Type of Survey Hydrographic Field Examination.
Field No. DA-5-1-78
Office No. FE-236

State Washington
General Locality Seattle
Locality Lake Union & Lake Washington
Ship Canal
19 81
CHIEF OF PARTY
CDR. N. C. Austin

DESCRIPTIVE REPORT TO ACCOMPANY
FIELD EXAMINATIONS, LAKE UNION AND LAKE WASHINGTON
SHIP CANAL, WASHINGTON (S-N916-PMC-80)

PACIFIC MARINE CENTER
VERIFIER'S REPORT

FIELD EXAMINATION (FIELD SHEET)

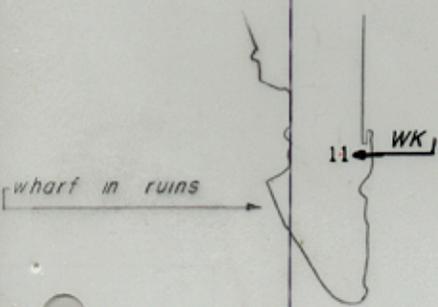
The shoal area is characterized by a layer of mud and silt over a hard bottom. The shoal is generally flat and lies just outside an area of private piers where small craft are moored. A least depth of ~~3.8~~^{4.8} feet (reduced to LWD) was determined by sounding pole at latitude 47°38'52.2" N, longitude 122°16'32.1" W (Position No. 4010). Identification of the location of the least depth was somewhat difficult due to the flatness of the bottom. *added bottom char M to smooth sheet.*

A 0.3 foot discrepancy exists between the least depth ~~3.5~~^{3.8} feet, reduced to LWD) and the Ross fathometer (~~3.5~~^{4.1} feet, reduced to LWD). This may be attributable to the layer of mud and silt over the hard bottom; the fathometer return is from the mud and silt while the sounding pole was planted firmly on the harder substrate. Plotted field sheet depths exaggerate the discrepancy because of the round-off routine in the plotting program. *Post#40018*

depth on shoal area = 38 feet taken by
sounding pole

There are no crosslines or bottom samples. Standard depth curves have been
completed within the limits of this Field Examination. *Pg 9 of D.R. "The shoal area
is characterized by a layer of mud & silt over a hard
bottom". M & silt were added to SS during Q.C.I. (4 ft sdgs. in
lat. 41° 38.87' N,
long. 122° 16.53' W)*
